Docket Item # 4 & 5
BAR CASE #2011-0247 &
2011-0248

BAR Meeting
September 21, 2011

ISSUE: Concept Review for a Permit to Demolish/Encapsulate and Garage Addition

LOCATION: 207 South Fairfax Street

Figure 6. Proposed site plan.

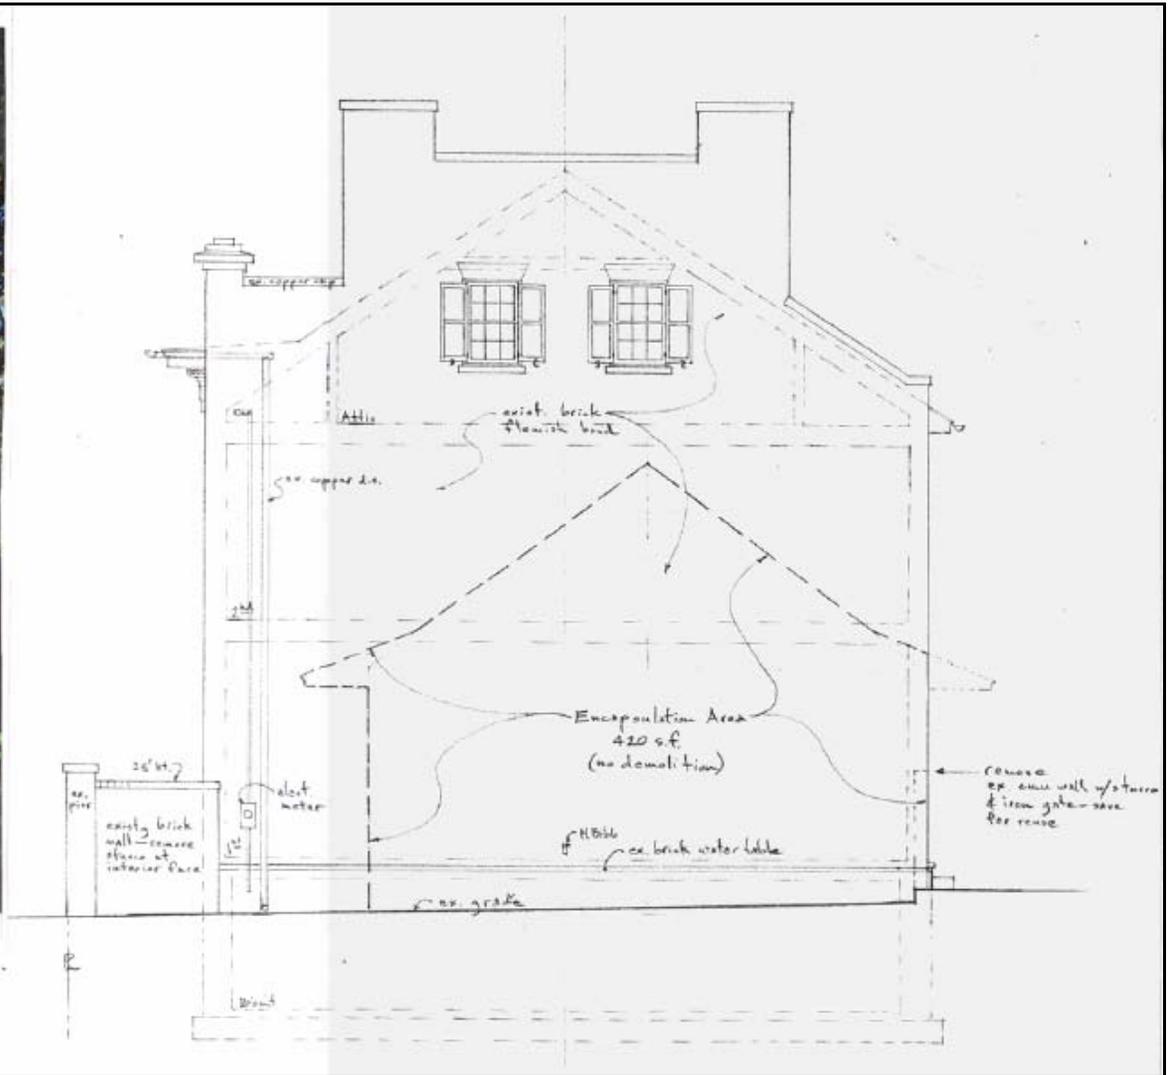
- F2. The curb cut at 203 S. Fairfax Street will not be useable with the current proposal and shall be removed. It shall be the responsibility of the applicant (207 S. Fairfax St) to close the curb cut currently in front of 203 S. Fairfax. (T&ES)

- R2. Applicant shall close existing curb cut currently shown at 203 S. Fairfax Street and install curb and gutter and brick sidewalk to City Standards. (T&ES)

Figure 7. Existing north wall and area proposed for demolition/encapsulation.

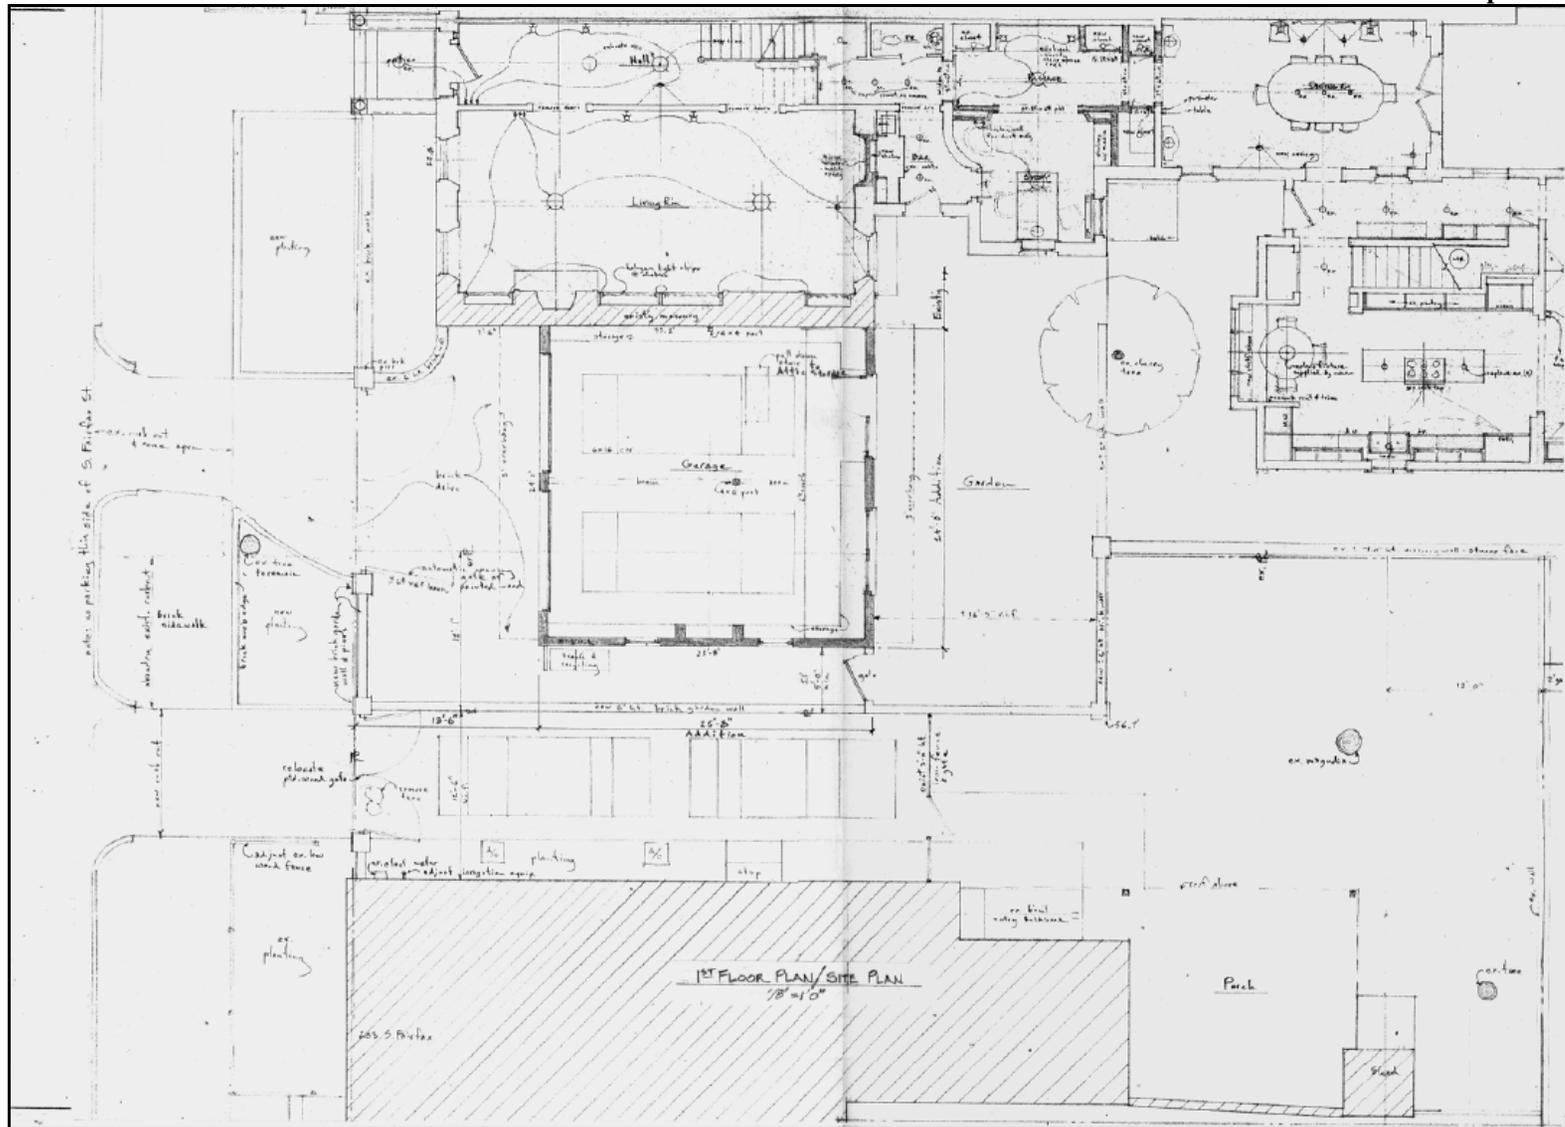
In the opinion of Staff, the extensive area proposed for encapsulation meets criteria 3 and 5 of the Permit to Demolish/Encapsulate in the current submission. Staff finds that the proposed encapsulation effectively results in the visual loss of the entire 18th-century brick wall on the north end of the house. While the proposed encapsulation does not cover the entire brick wall, it will encapsulate more than 50% of the existing wall. Although the applicant states that the wall will only be encapsulated, not demolished, once the Board approves an encapsulation the area is no longer within the Board's purview, unless an easement is obtained. While some small amount of demolition and encapsulation may be reasonable, Staff believes that a significantly smaller garage addition would result in a more acceptable amount of encapsulation and leave the majority of the historic wall visible to the public. The current wall illustrates historic masonry construction techniques and also shows the evolution of the house with the bricked in opening. As many townhouses in the district are attached or closely spaced, opportunities to clearly view side elevations are limited.

Figure 9. Proposed front (east) elevation.

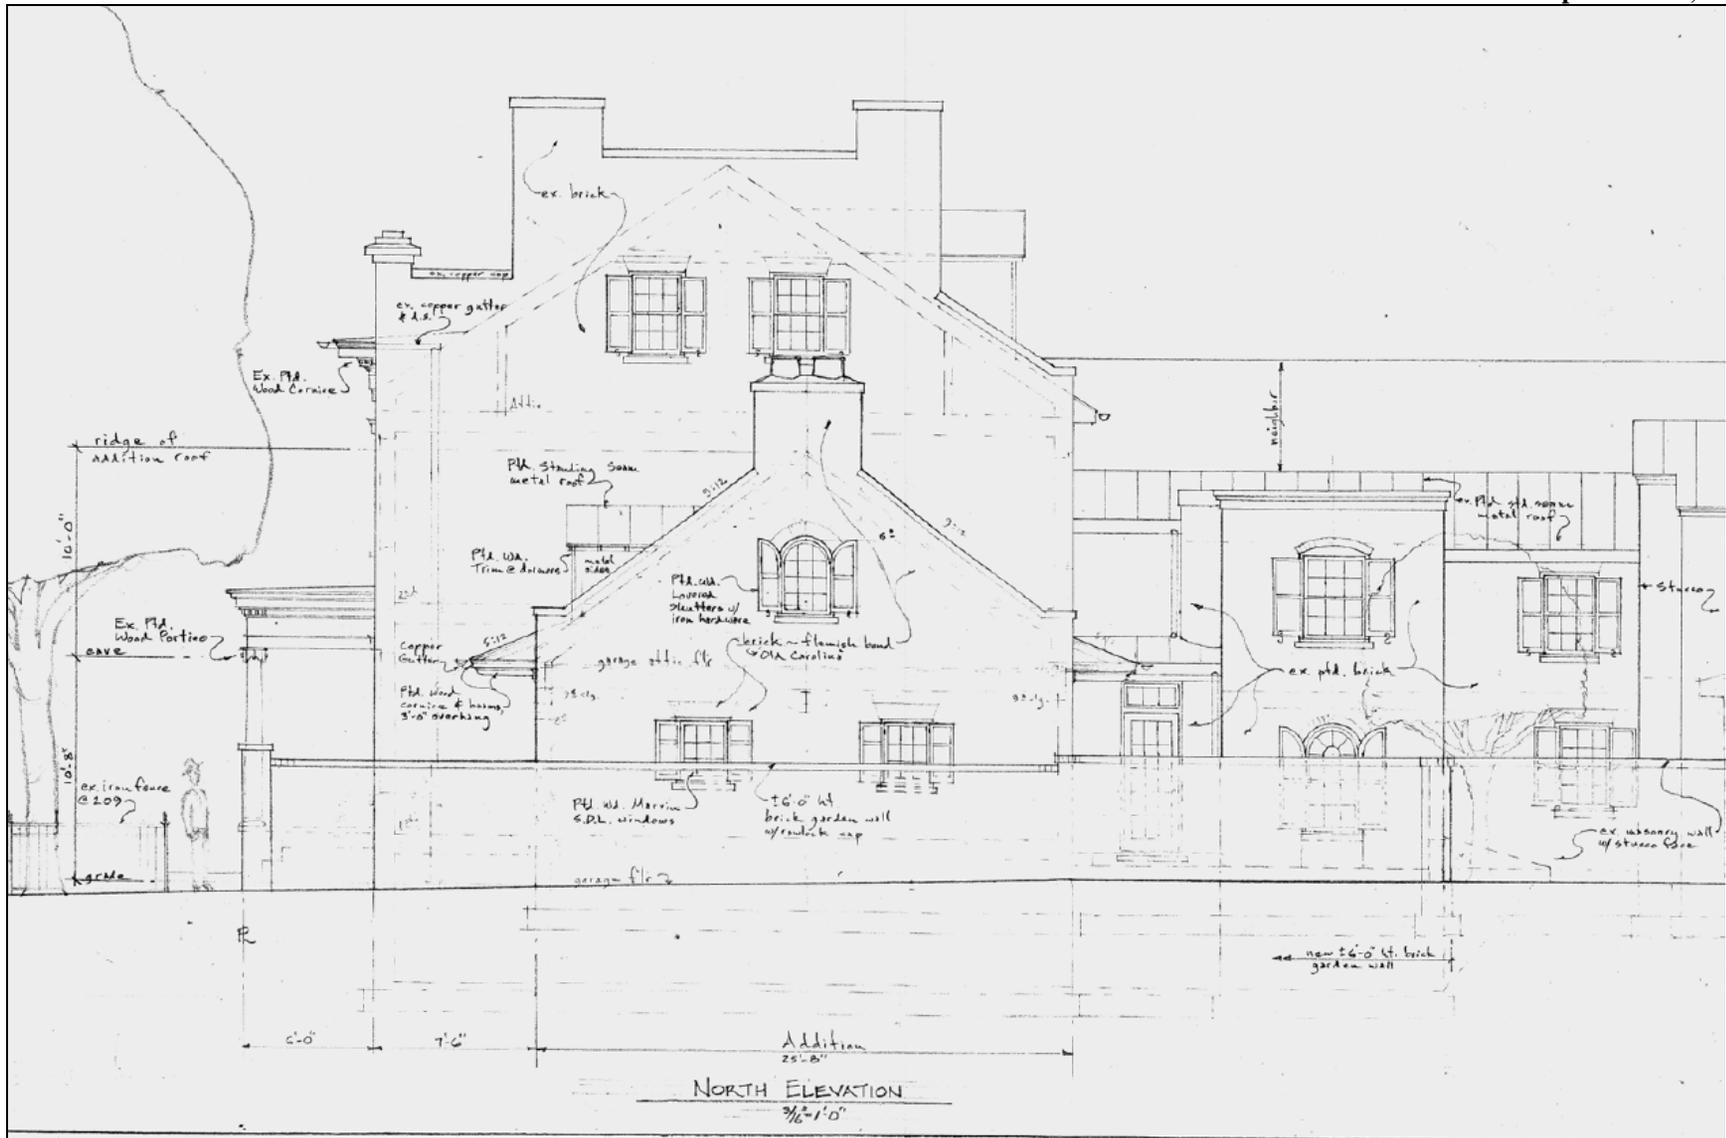
Staff does not find the proposal appropriate with respect to the massing and scale of the existing adjacent houses. Staff notes that the proposed garage addition, although recessed from the street, will be even wider than the existing townhouse. Further, the garage addition is larger than many entire townhouses found in this area of the historic district. While the attention and level of architectural detail of the garage are commendable, Staff can only support a more minimal, yet still high-quality, type of detailing that is deferential to the historic architecture and surrounding open space.

While Staff does not support the current proposal, Staff could support a significantly scaled-down garage addition at this location because it can be set back from the street and largely obscured by a garden wall and gate. Staff recommends that the applicant restudy the proposal to devise a solution that allows the addition to serve as a contextual background element. The proposed garage addition should be no more than one-story with a flat roof and must read as a diminutive background building. Due to its adjacency to the garden and garden walls, a different style garage addition could potentially incorporate features of a garden structure, such as a trellis or arbor. These changes would reduce the massing and scale of the garage addition and allow it to visually relate to the surrounding garden area. In addition, when the gates are closed, due to the setback of the building, the garage will greatly recede from the street and allow the historic townhouse to retain its prominence.
